HISTORIC AND DESIGN REVIEW COMMISSION

July 1, 2020

HDRC CASE NO: 2020-251
ADDRESS: 2158 W KINGS HWY
LEGAL DESCRIPTION: NCB 6825 BLK LOT 15 & W 12.5 FT OF 14
ZONING: R-6, H
CITY COUNCIL DIST.: 7
DISTRICT: Monticello Park Historic District
APPLICANT: John Speegle, speegle & KIM-davis Architecture
OWNER: William Hazlewood
TYPE OF WORK: Enclosure of front porch with windows and door
APPLICATION RECEIVED: April 03, 2020
60-DAY REVIEW: Not applicable due to City Council Emergency Orders
CASE MANAGER: Huy Pham

The applicant is requesting a Certificate of Appropriateness for approval to enclose the front porch to feature aluminum windows in the two front arches and doors in the side-facing arches.

not in part of same permit

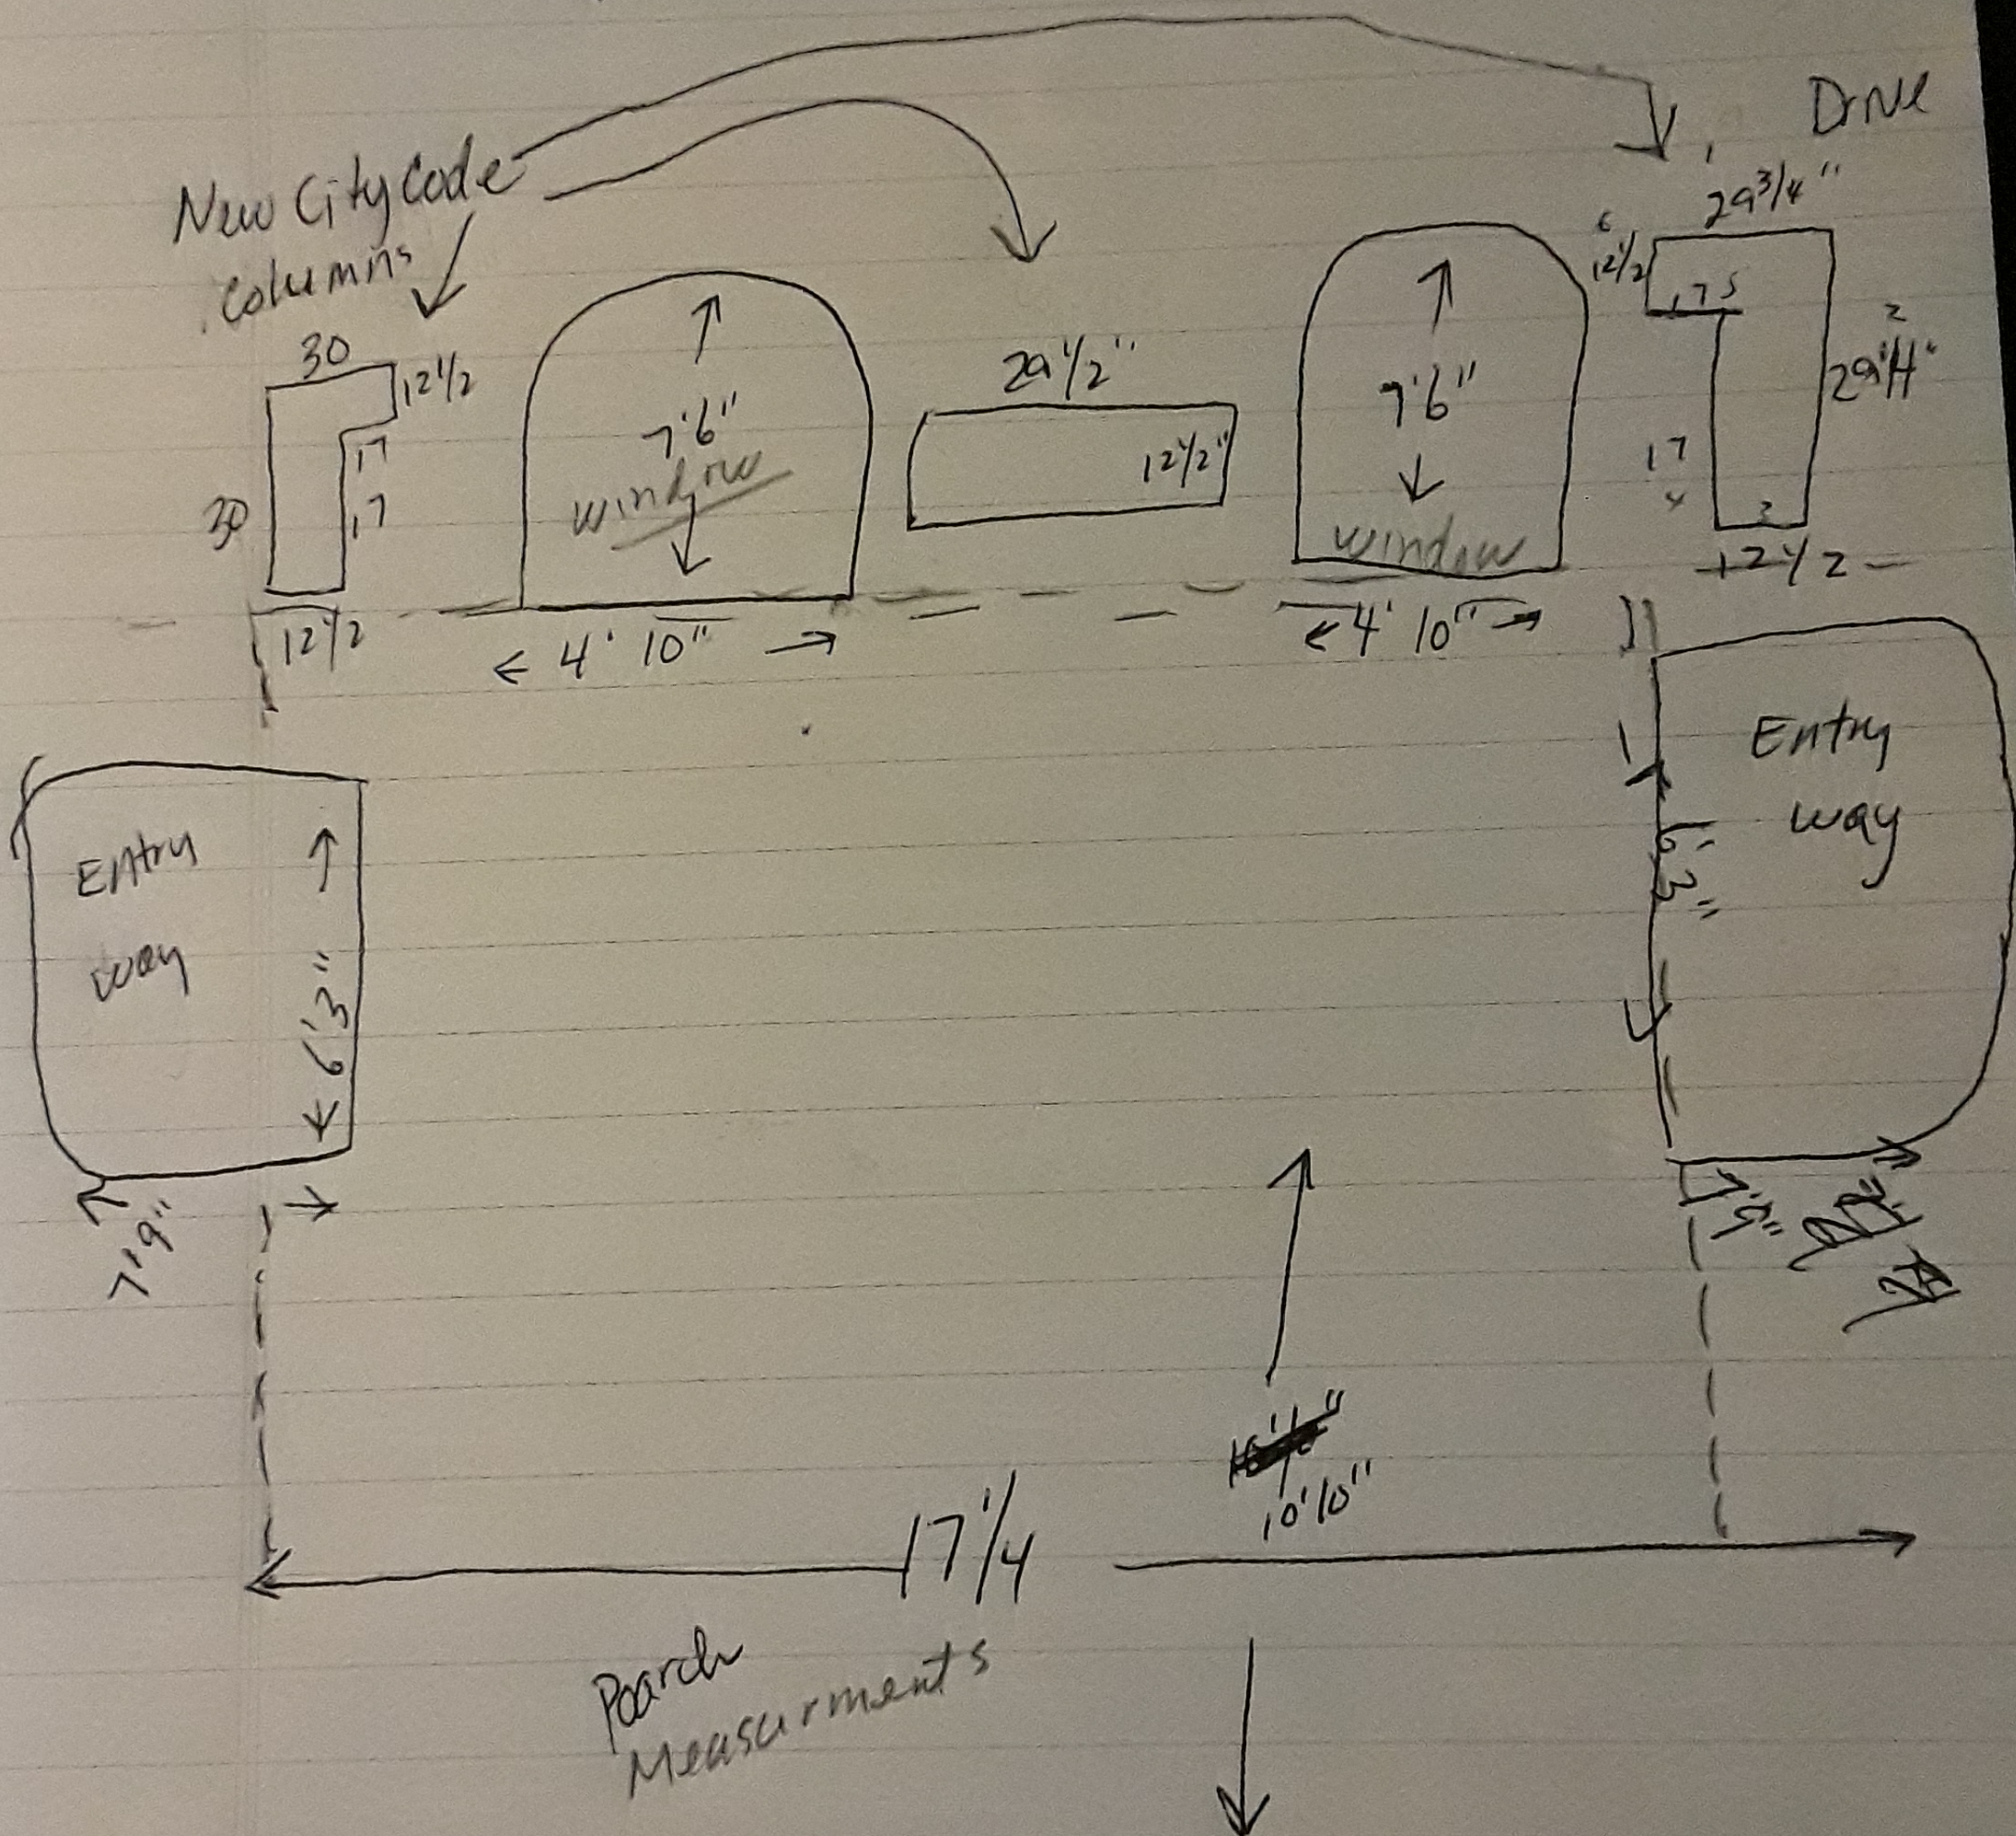
- Measured, dimensioned drawings that illustrate how a screened porch will look as installed on your home. The drawings you submitted are a good start though they should have measurements and dimensions.
